L-2015-056
10 CFR 52.3

Re: Florida Power & Light Company
Proposed Turkey Point Units 6 and 7
Docket Nos. 52-040 and 52-041
Voluntary Revised Response to NRC Request for Additional Information Letter No. 041 (eRAI 6024) SRP Section: 02.05.01 - Basic Geologic and Seismic Information

NRC RAI Number: 02.05.01-16 (eRAI 6024)

NRC RAI Number: 02.05.01-20 (eRAI 6024)

Figure 1. Location Map for Profiles Shown in Figures 2 through 10

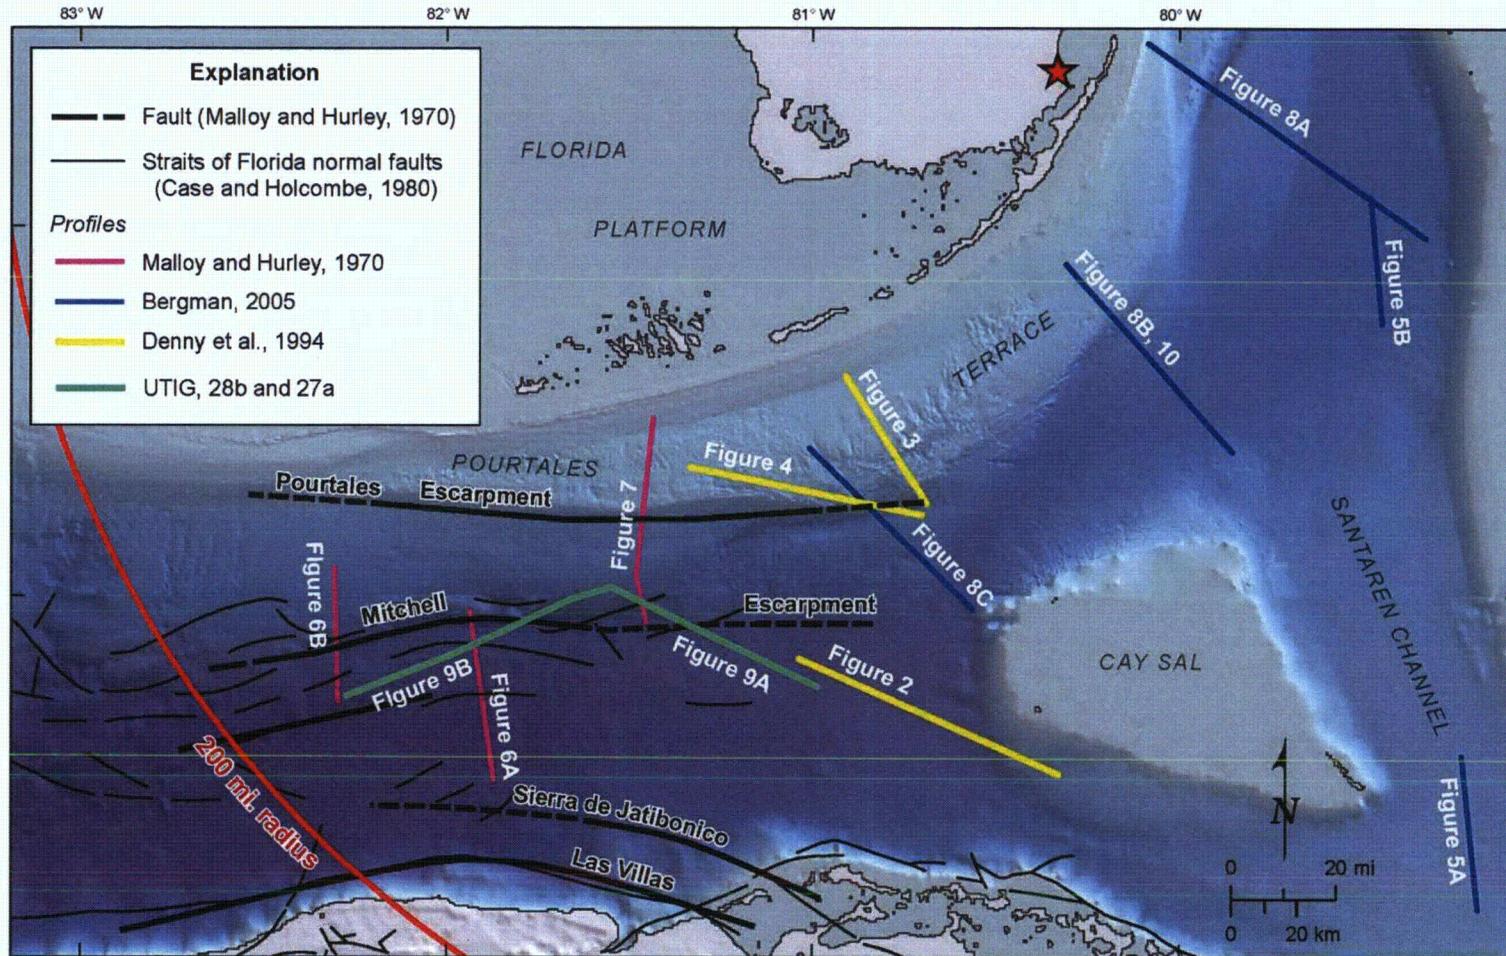
In order for the staff to completely understand the geologic setting of the TPNPP site and in support of 10 CFR 100.23, Provide a discussion of the structural and stratigraphic evidence for the location and timing of deformation along the Mitchell, Pourtales, and Miami escarpments, the Las Villas and the Sierra de Jatibonico fault zones, and other tectonic features present in the bathymetry of subsurface of the Straits of Florida within the site region, including those located offshore northern Cuba, and in light of references such as Uchupi, 1966^a and Malloy and Hurley, 1970^b.

Malloy and Hurley (Reference 3) present compiled bathymetric and seismic reflection data for the Straits of Florida. They identify escarpments in the Straits of Florida and postulate the existence of faults, including the offshore Las Villas fault and offshore Sierra de Jatibonico fault (Figure 1). Malloy and Hurley (Reference 3, p. 1962) indicate that “since traverses could not be made within 12 [nautical miles] of Cuba, no seismic reflection profiles were obtained of these steep and complex slopes.” As such, they base their offshore mapping of the Las Villas fault on Khudoley’s (Reference 2.5.1-910) previous mapping and on their compiled bathymetric data. Malloy and Hurley’s

Reference 2.5.1-493). Only portions of the mapped trace of the Las Villas fault from Malloy and Hurley (Reference 3) coincide with the steepest portions of the slope, and Malloy and Hurley's (Reference 3) Sierra de Jatibonico fault does not appear to coincide with any scarps in the bathymetry (Figure 1). The DNAG Map of North America (Reference 7) shows the same faults as Malloy and Hurley (Reference 3) in the Straits of Florida region, with two additions near the Las Villas and Sierra de Jatibonico faults (faults 1 and 2 on Figure 11). A fault is included south of the unnamed escarpment and northwest of the Sierra de Jatibonico fault that cuts Neogene sediments (fault 3 on Figure 11), and a segmented fault is included along the steep portion of the slope north of the small islands and east of the Sierra de Jatibonico fault that cuts Tertiary strata (fault 4 on Figure 11). The latter structure is coincident with representations of the Nortecubana fault in this area (e.g., FSAR Figure 2.5.1-202). The offshore area near the Nortecubana fault and south toward the Cuban coast is expected to be underlain by thrusts of the Cuban fold-and-thrust belt, which are covered by unfaulted late Tertiary and Quaternary strata (FSAR 2.5.1 References 484, 485, and 497) (FSAR Figures 2.5.1-279, 2.5.1-280, 2.5.1-282, 2.5.1-287, and 2.5.1-288).

Figure 11. DNAG Map - GMNA of Straits of Florida Region

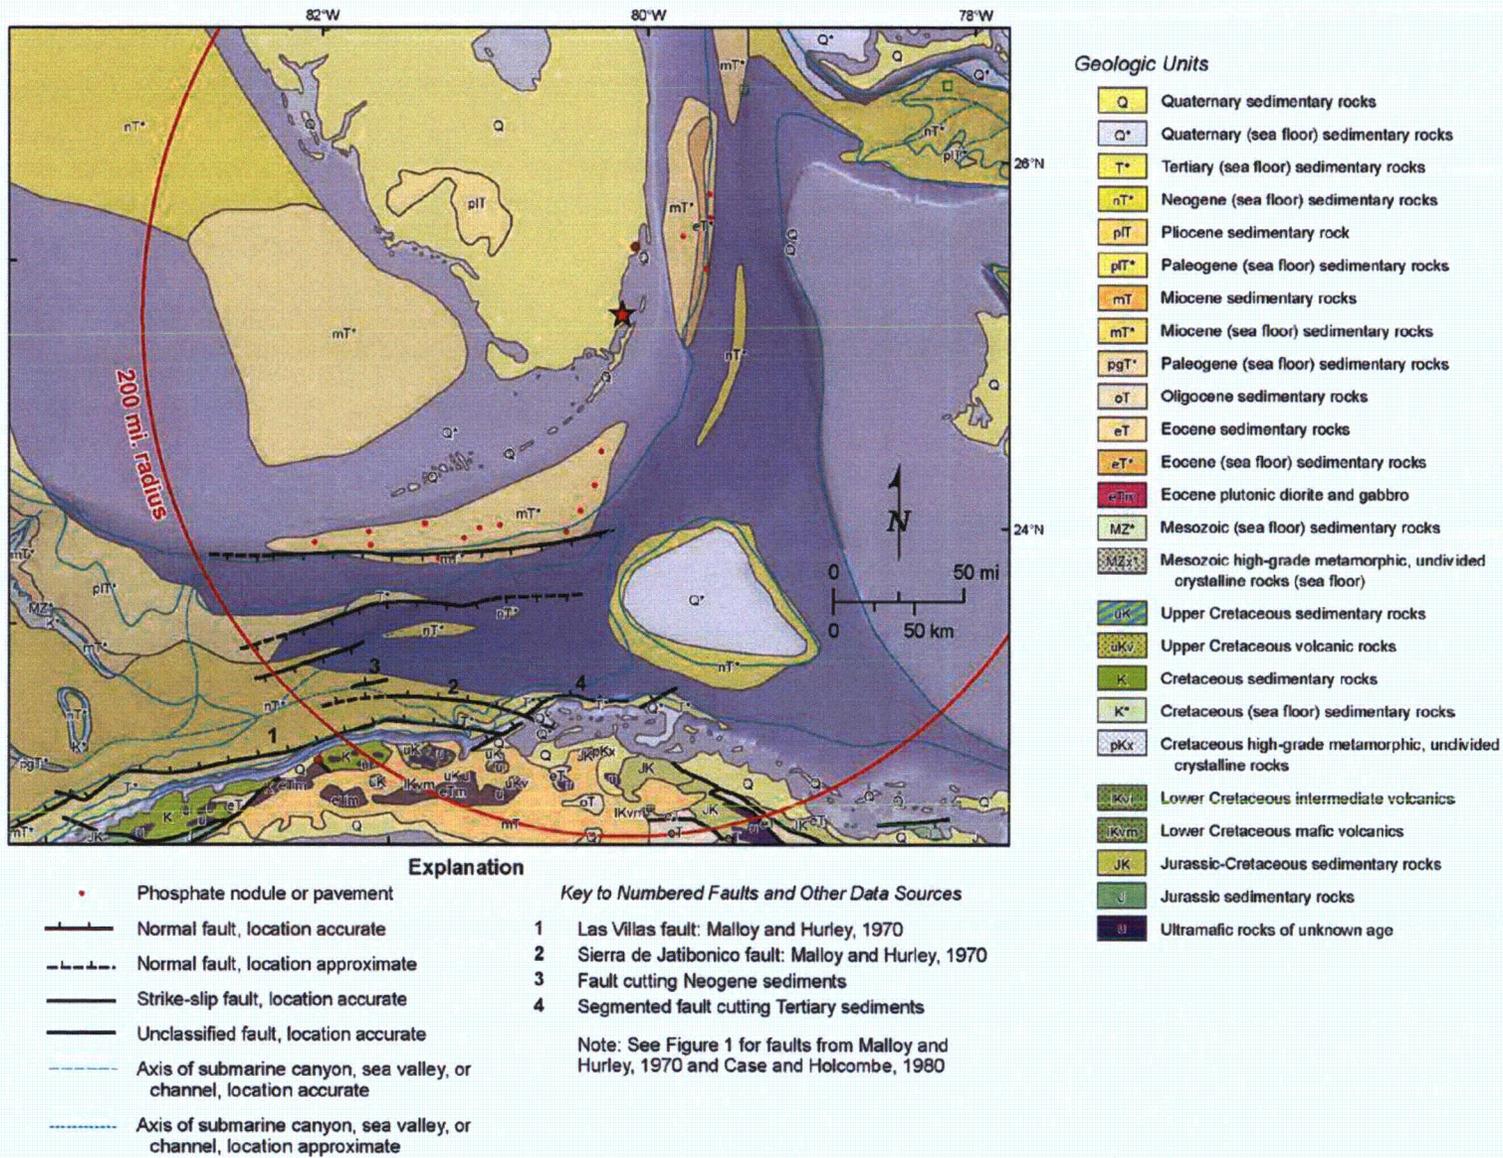
In the Reference provided, FPL submitted revised responses to Requests for Additional Information (RAI) 02.05.01-16 and 02.05.01-20. In subsequent discussions to the submittal, the NRC staff requested that for the revised response to RAI 02.05.01-16 FPL label the faults on Figure 11 to provide clarity to the discussion of the DNAG map. FPL has updated the response to include labels for the faults on Figure 11 of the response, including editorial changes. For RAI 02.05.01-20, the NRC staff noted that Attachment A was not included with the response. FPL has updated the response to replace the reference to Attachment A with a citation to Angell and Hitchcock.

has confirmed this (e.g., Reference 4, FSAR 2.5.1 References 221 and 906). Although the faults mapped along the Pourtales, Mitchell, and unnamed escarpments from Malloy and Hurley (Reference 3) are included in compilation maps such as the DNAG Map of North America (Figure 11) (Reference 7), it is unclear whether this represents the initial compilation efforts of the early 1980s, or whether newer, but unpublished, mapping supports the notion of faulting at that location. The relationships indicated on the DNAG map indicate that the faults cut surficial sediments with ages as young as Pliocene, and the faults are generally dashed in Quaternary strata (Figure 11) (Reference 7).
